CONCEPT PLAN

WHIP CLEAN
CITY OF GAITHERSBURG
MONTGOMERY COUNTY, MARYLAND

SP-8819-2021 Initial Plan- Staff Comments

Planning Staff Comments

SITE DEVELOPMENT CONCEPT PLAN

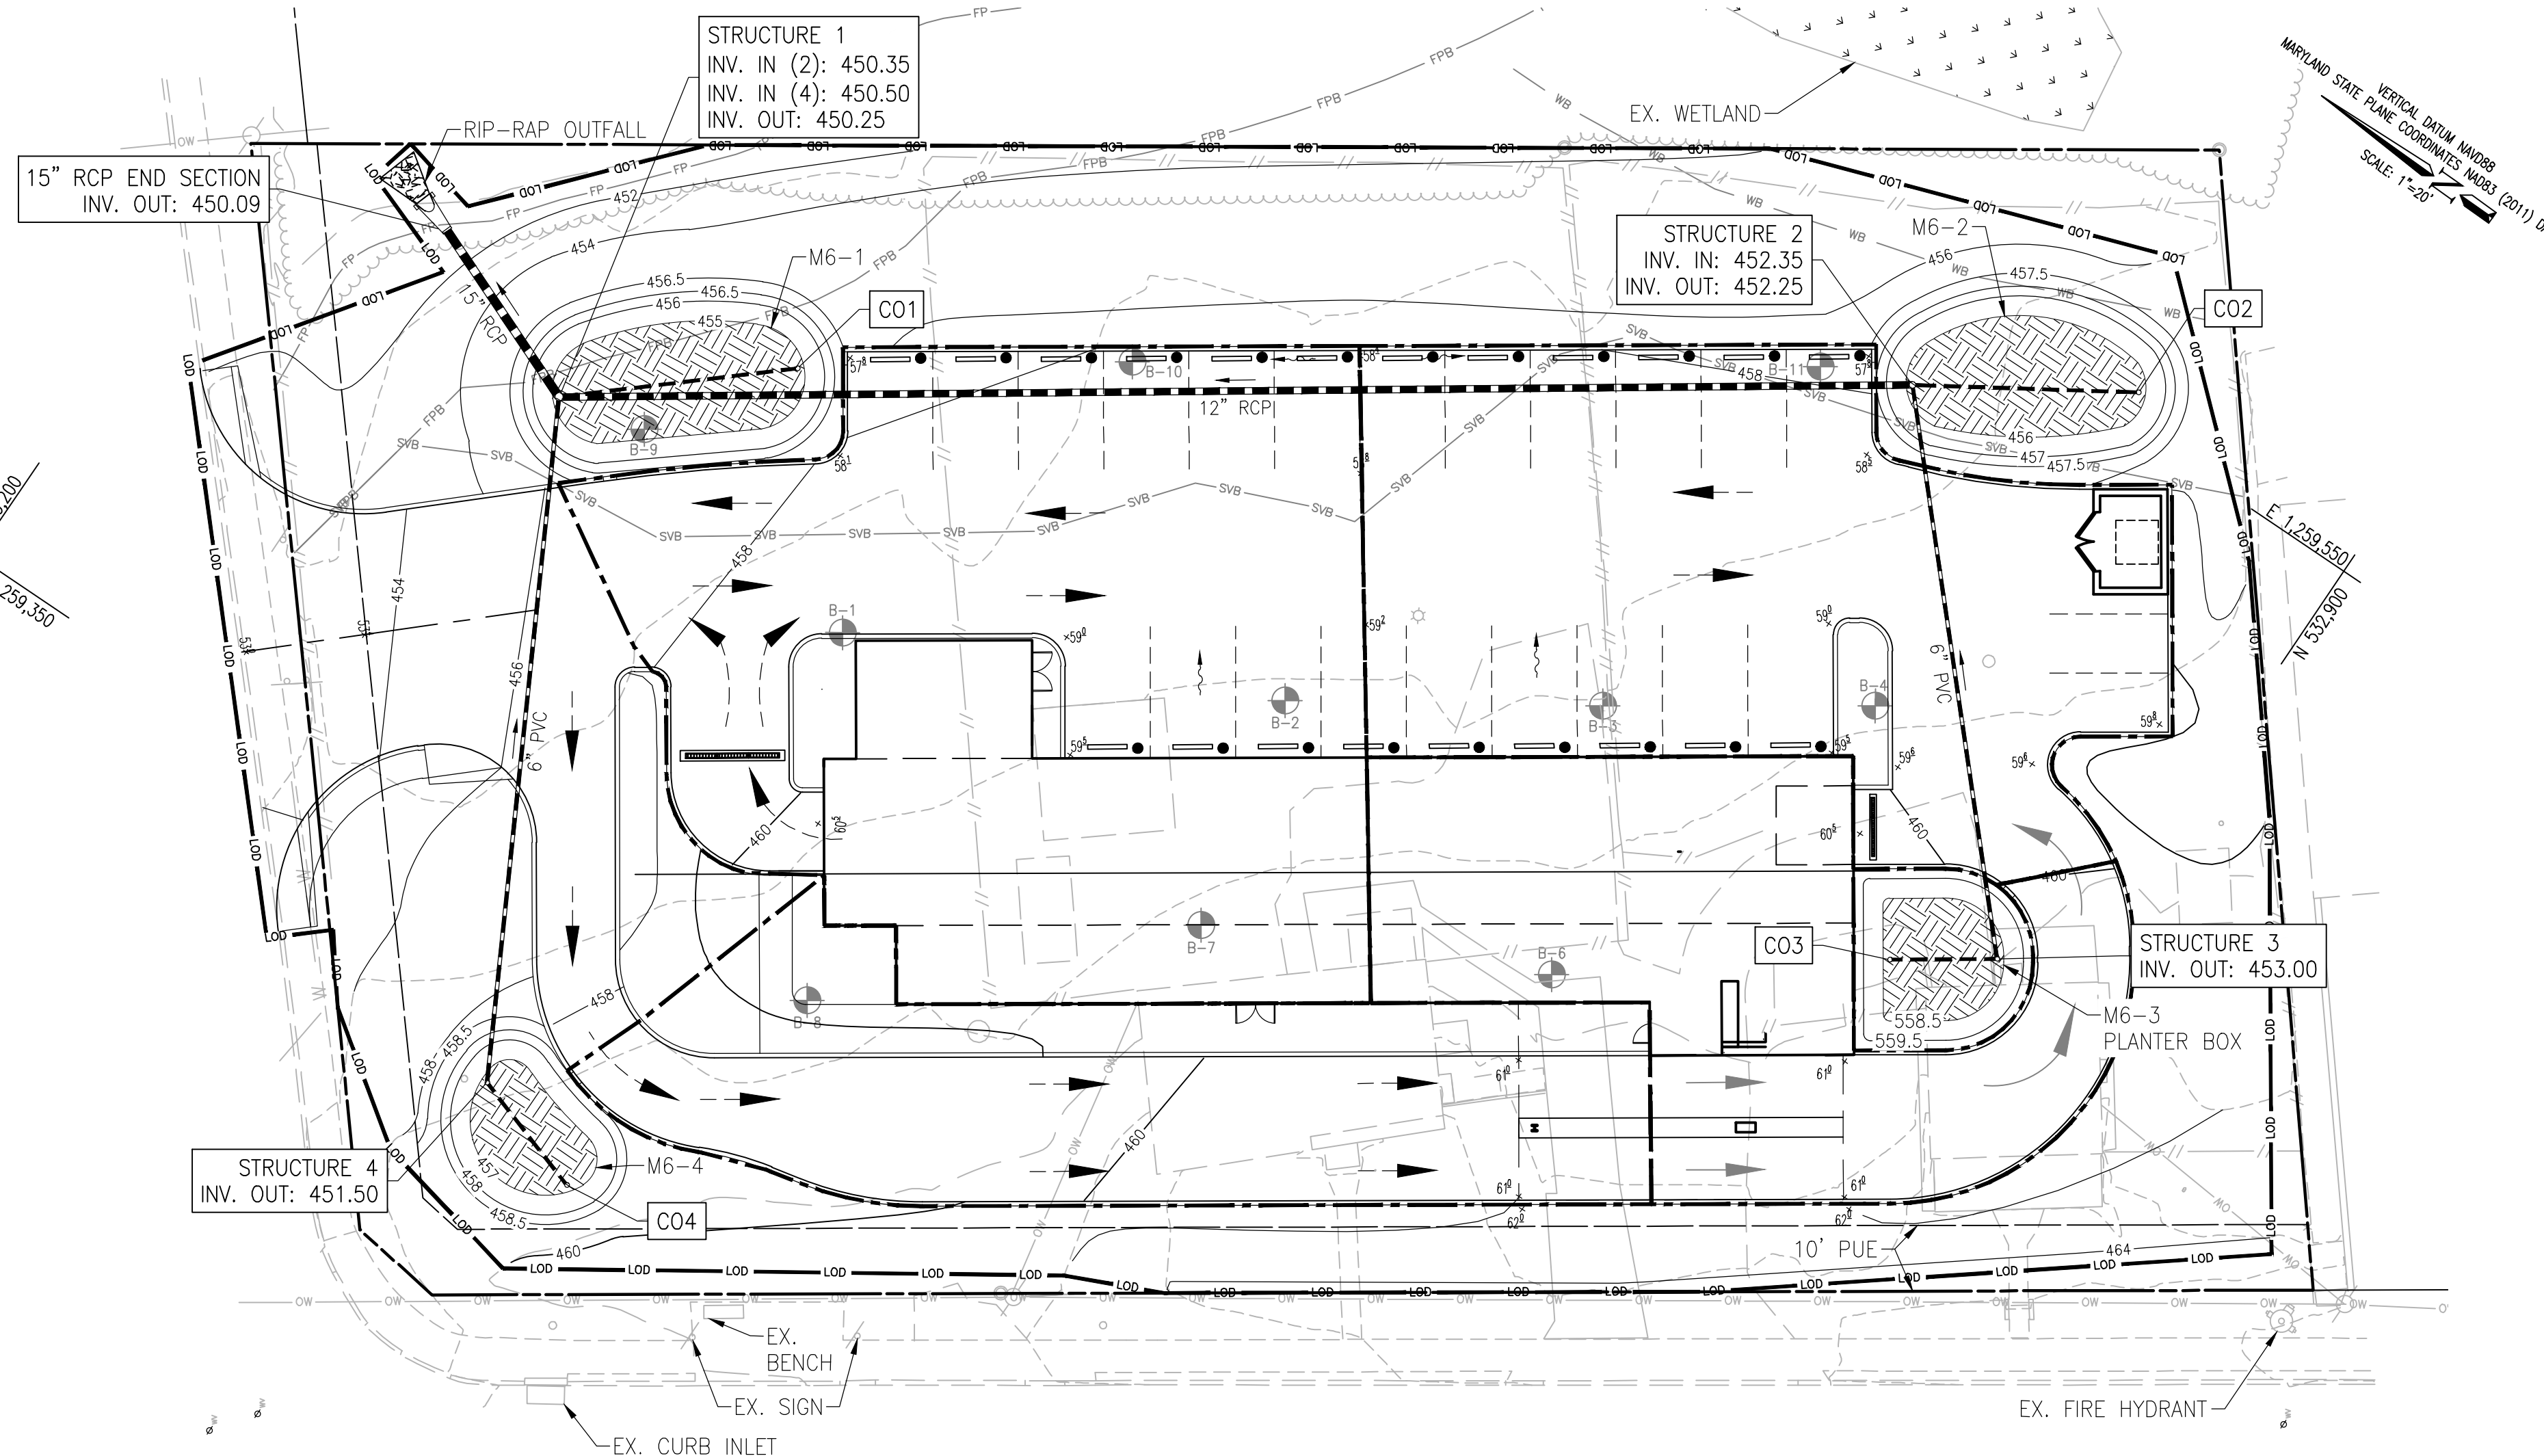
Need to provide building height and width dimensions

- Show double stripe for parking spaces per code typical comment throughout
- Suggest having concrete pad in front of dumpster enclosure to prevent rutting over time.
- Cleanup plan to show remove labels that are not applicable on this plan. Add an existing conditions plan and demolition plan.
- Entrance/DW permit from MC DPS required
- Add a cover sheet with sheet count for the plan, concept plan number, legend, vicinity map, etc.
